Vieux Carré Commission Architecture Committee Meeting

Tuesday, September 10, 2024

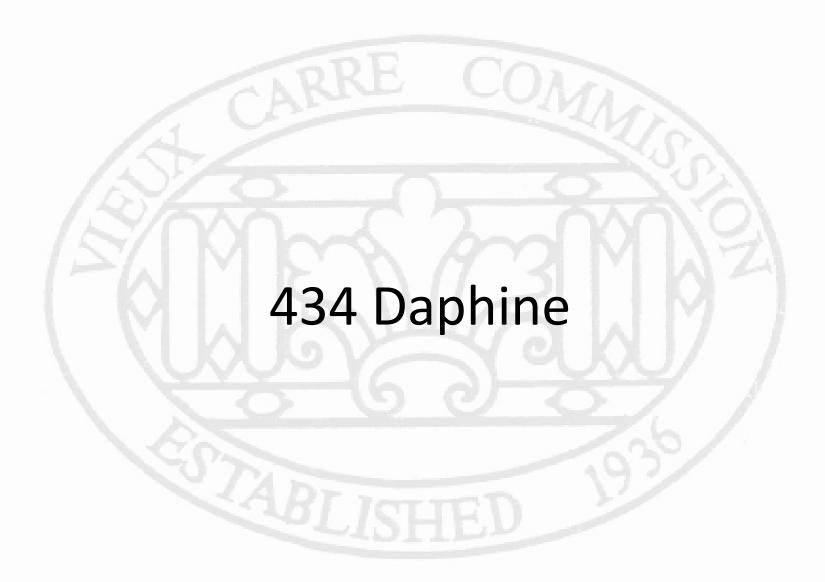
The applicant proposes to replace the existing alleyway gate with a new style of wood gate. The existing wood gate was reviewed and approved in 2016. The proposed new gate utilizes a heavier rail and stile design with V groove panels noted as being on both sides. The existing decorative ironwork is noted as being retained and installed in the new gate. Staff questions the details of the submitted section drawing as it appears there is a weak point in the door where there would only be a single layer of V groove board coming together.

Staff has no objections to the concept of replacing this gate as the existing is not historic and only loosely based on historic precedence. Staff finds the proposed new gate atypical as it seems to be a mix of two typical, but significantly different, wood gate designs. Staff suggests that using more simplified panels, rather than the V groove boards as panels, may be more typical. There are numerous examples of alleyway gates that are very similar to typical wood paneled doors, although the most common wood gates appear to be fully V or beadboard, with or without some kind of cutout.

Staff requests commentary from the Committee but suggests that a conceptual approval may be appropriate if the applicant is agreeable to using a more typical gate design.
